# Technical Service Bulletin

## 50 Creaking noise in front instrument panel area

50 22 09 2066526/1 March 22, 2022.

Model(s)	Year	VIN Range	Vehicle-Specific Equipment
A8, S8 (4N8)	2019 – 2021	All	Not Applicable
A8, S8 (4NL)	2022	000001 - 001988

**Figure 2.** The front suspension strut tower brace and associated bolts.

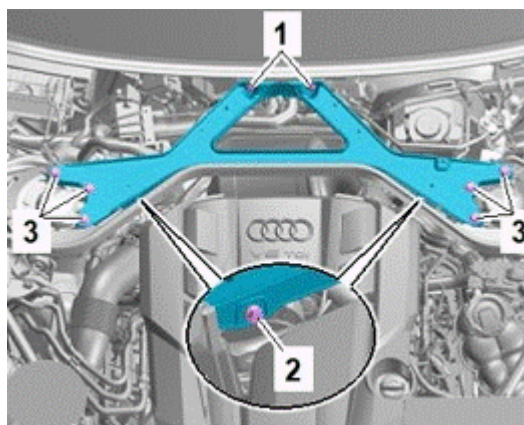
A visual inspection finds the mounting bolts for the front suspension strut tower brace not tightened. This allows the front suspension strut towers to move slightly in steering or braking maneuvers and generates a creaking noise between the brace and the strut tower.

If any of the bolts shown in positions 1 or 3 in Figure 2 are found to be loose, all of the bolts in positions 1 and 3 must be replaced as specified in the repair manual. Torque in the sequence and tension specified in the repair manual. The bolt labeled number 2 in Figure 2 may be reused and retightened to the specified torque and in the correct sequence.
